RULE NO.: R161-18.21**NOTICE OF RULE ADOPTION****ADOPTION DATE: December 7, 2018**

R161-18.21: Notice of Adoption to the Standard Details 1300.

CONCRETE URBAN TRAIL
CONTRACTION JOINT DETAIL - OPTION 1

STANDARD NO.
1302S-2
1 OF 1

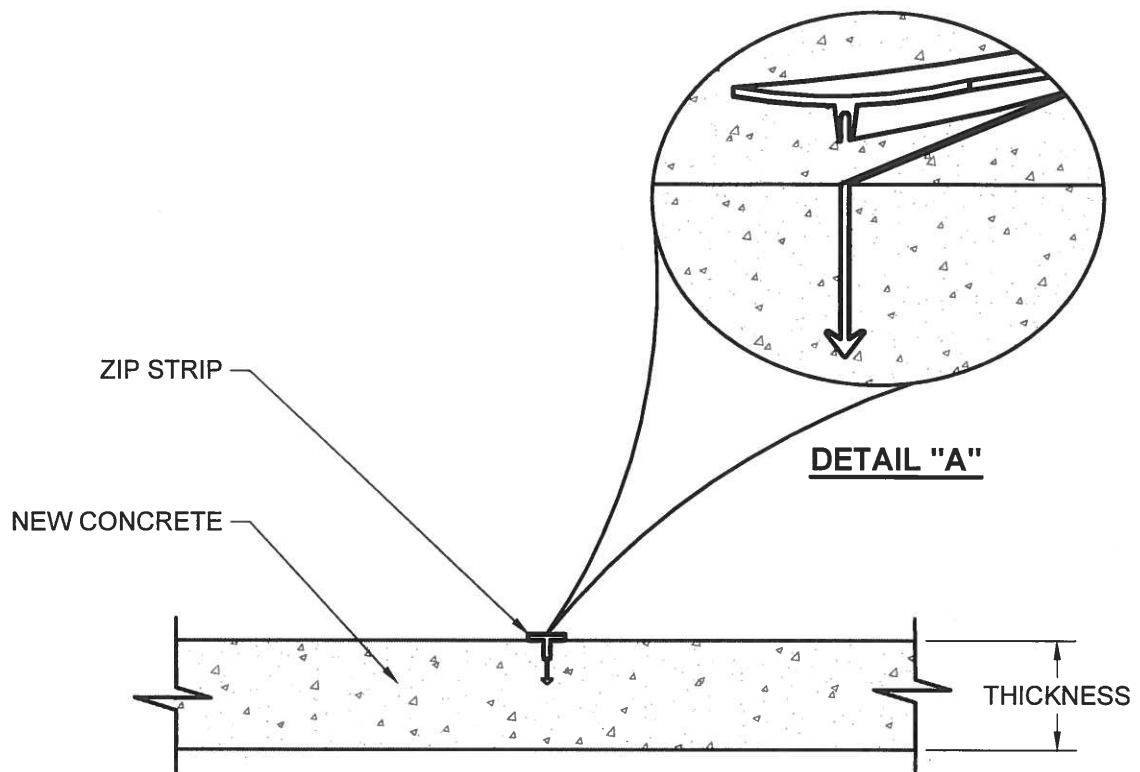
- Standard Detail 1302S-2 - This detail is being created to add a contraction joint detail for concrete urban trails.
